YUCCA MOUNTAIN - SUPPLEMENTAL RESPONSES TO REQUEST FOR ADDITIONAL INFORMATION - SAFETY EVALUATION REPORT, VOLUME 3, CHAPTER 2.2.1.2.1 (SCENARIO ANALYSIS), 4TH SET (U.S. DEPARTMENT OF ENERGY'S SAFETY ANALYSIS REPORT SECTION 2.2.1.2)

RAI Volume 3, Chapter 2.2.1.2.1, Fourth Set, Numbers 25 and 26, Supplemental Question:

RAI Volume 3, Chapter 2.2.1.2.1, Fourth Set, Number 36, Supplemental Question:

Figure 1. Δk_{eff} Values between Calculated and Measured Isotopic Compositions

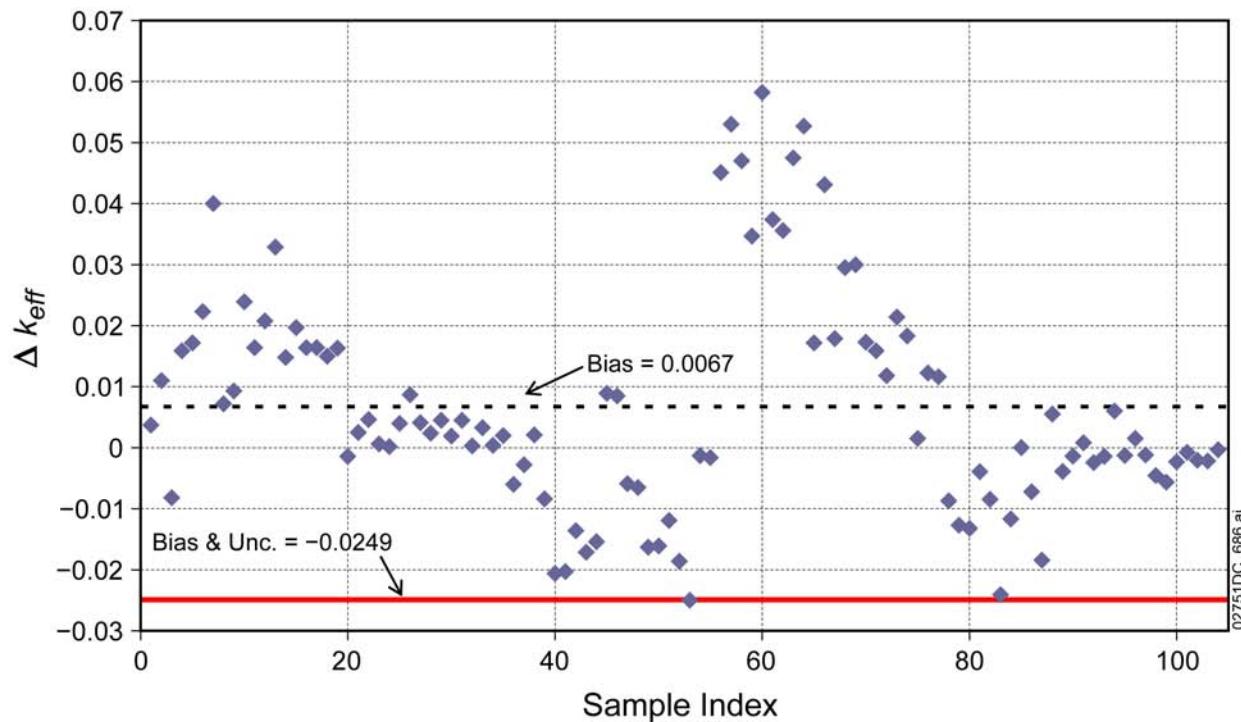
Where in the responses to RAIs 3.2.2.1.2.1-4-025 and 3.2.2.1.2.1-4-026 did DOE justify crediting the five metal isotopes (^{95}Mo , ^{99}Tc , ^{101}Ru , ^{103}Rh , and ^{109}Ag)?

Only 11 radiochemical analysis (RCA) samples, all from TMI-1 RCA data, were supplied for most of these metals. The measurement methods used for these samples involved relatively low-precision techniques resulting in large experimental uncertainties. No justification was provided to support the small sample size as bounding the inventory of pressurized water reactor (PWR) spent nuclear fuel (SNF) assemblies and the associated uncertainties in the data.

Given the lack of data, provide additional information on how the uncertainties associated with measuring and predicting the isotopic composition as well as the uncertainties in the available RCA samples are accounted for when representing the bounding isotopic composition for the various PWR assembly fuel types and operating histories.

Each of the radiochemical analysis (RCA) data sets has a different total number of nuclides that were measured, but collectively these data sets include measurements for all of the principal isotopes identified in SAR Table 2.2-9, including the five metal isotopes listed in the RAI. These data sets were evaluated using the “direct-difference” method (Gauld 2003, Section 3.2.3) to quantify the net bias and uncertainty in the k_{eff} calculation due to the variability in the predicted nuclide concentrations. All publicly available at the time of LA submittal RCA data were included in the evaluations. In order for the direct-difference method to be used, the data population needs to include measurements for all radionuclides selected for burnup credit analyses. The Three Mile Island (TMI) data set contains measurements for the five metal fission products cited in the RAI. When using the direct-difference approach, individual isotopic measurement uncertainty is not evaluated directly but is reflected across the sample population and captured in the k_{eff} results. The TMI data have larger experimental uncertainties, which are noticeable in the Δk_{eff} calculations, and therefore result in a larger overall variance within the Δk_{eff} sample population. By using the direct-difference approach, the individual laboratory systematic errors are captured along with the individual nuclide uncertainties, and the aggregate effect is calculated as a Δk_{eff} value. By evaluating the RCA data collectively with the direct-difference approach, the net bias and uncertainty on k_{eff} (Δk_{ISO}) is determined for the system of interest. The mean bias within the total sample set is 0.0067 but due to the large variance within the sample set and the fact that the data are not normally distributed, the distribution-free tolerance limit method is used to calculate the lower-bound tolerance limit, which incorporates a very large uncertainty penalty (as compared to a normally distributed sample population), resulting in a net bias and uncertainty (Δk_{ISO}) of -0.0249 (Figure 1). This large Δk_{eff} penalty is primarily due to the spread (uncertainty) in the data as well as the low sample count, and is applied directly in the calculation of the critical limit.

The collective uncertainty penalty factor associated with the Δk_{eff} distribution (0.0067 – (-0.0249) = 0.0316) is much larger than the effects on k_{eff} of the uncertainty associated with the measurements of the individual nuclides for the metal fission products. Example reactivity sensitivity factors provided in *Evaluation of Cross-Section Sensitivities in Computing Burnup Credit Fission Product Concentrations* (Gauld and Mueller 2005, Table 16) demonstrate that the differential change in system k_{eff} due to a change in the macroscopic cross sections (which is reflective of changes in the isotopic number density), $\frac{\delta k / k}{\delta n / n}$, (^{103}Rh , 8.24×10^{-3} ; ^{99}Tc , 2.8×10^{-3} ; ^{95}Mo , 1.46×10^{-3} ; ^{109}Ag , 1.11×10^{-3} ; ^{101}Ru , 8.95×10^{-4}) is bounded by the collective Δk_{eff} uncertainty (i.e., 3.16×10^{-2}). The large Δk_{ISO} penalty factor, which is used in conjunction with conservative assumptions relative to fuel types and operating histories, provides reasonable assurance that uncertainties in isotopic predictions are bounded in the loading curve analysis. As additional data become available and can be included in the sample population, the data uncertainty is expected to decrease, resulting in a smaller isotopic bias and uncertainty (Δk_{ISO}) and greater margins in the current analysis results.

Figure 1. BWR Loading Curve

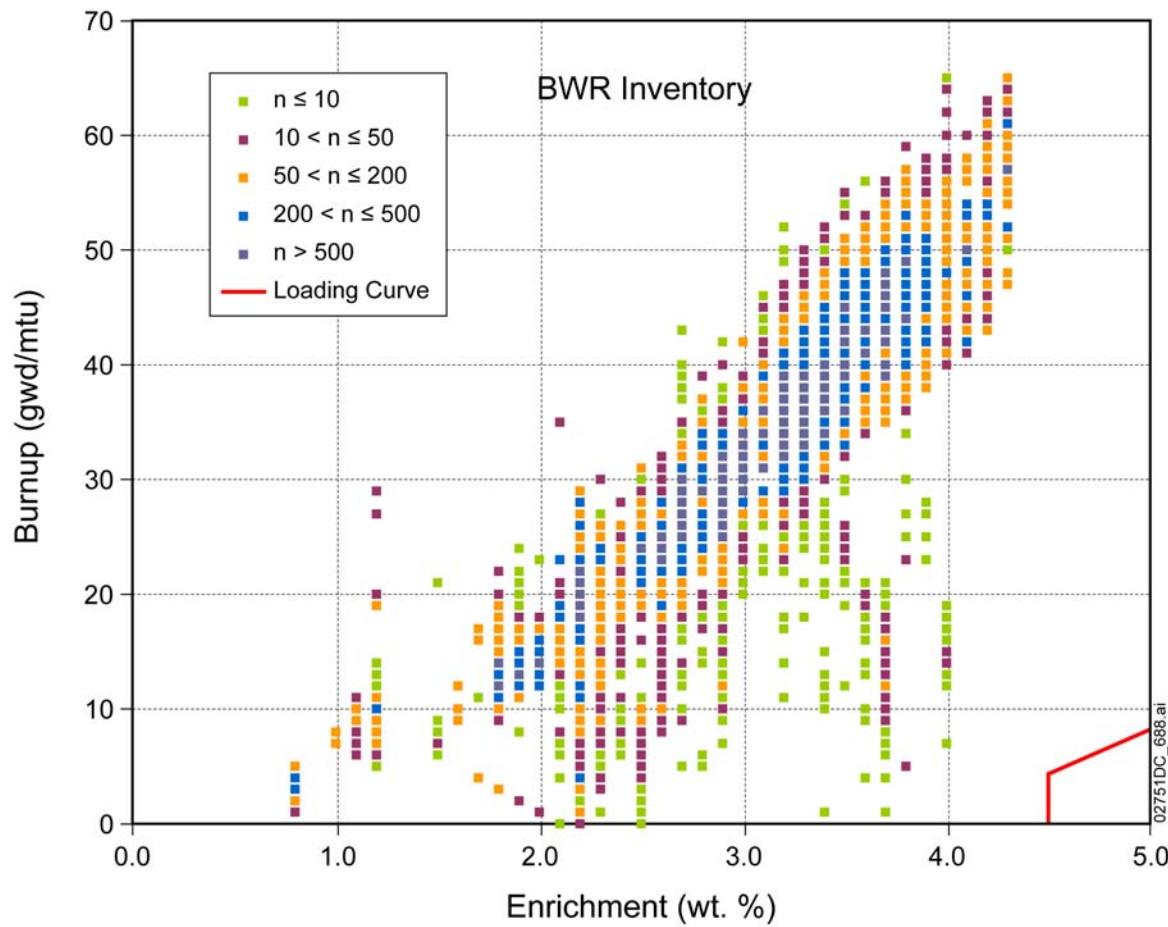
Where in the response to RAI 3.2.2.1.2.1-4-036 did DOE account for uncertainties in modeling isotopic compositions for boiling water reactor (BWR) spent nuclear fuel (SNF)?

Given the lack of BWR radiochemical assay (RCA) samples and the greater complexities of BWR SNF characteristics, justify that the analytical methods and supporting data used to generate the BWR loading curve adequately bound the BWR SNF inventory.

Because 4.5 wt% ^{235}U is the maximum enrichment that can be loaded into disposal canisters as fresh fuel, some BWR burnup credit is necessary to accommodate fuel assemblies with higher initial enrichments (i.e., > 4.5 wt% ^{235}U) than the projected waste stream inventory illustrated in Figure 1. As can be seen in Figure 1, only a very small amount of burnup credit, ~8 GWd/MTU (less than what is obtained in a typical irradiation cycle), is required for disposal of BWR fuel assemblies up to 5.0 wt% ^{235}U initial enrichment. Note at this low burnup and below, modern BWR assemblies have Gd_2O_3 remaining in the fuel, which reduces their reactivity. The BWR design basis assembly used in the generation of the BWR loading curve is a GE-2a 7×7 assembly with no burnable absorbers, no water rods, and depleted under extreme conditions to harden the neutron spectrum and breed in excess plutonium as discussed in *Isotopic Generation and Confirmation of the BWR Application Model* (Wimmer 2004; Massie 2004). This assembly design is representative of a “simple” BWR assembly design as compared to the newer and more advanced fuel designs that incorporate the use of integral burnable absorbers, part-length rods, water holes, higher initial enrichments as well as axially varying enrichments, and other features (all designed to increase overall fuel residency time, i.e., extend burnup). The design improvements of the more advanced designs ultimately result in a net decrease in the total fissile mass available in the fuel assembly at discharge (i.e., fuel is replaced with burnable absorber, and removed from part-length rods and water holes).
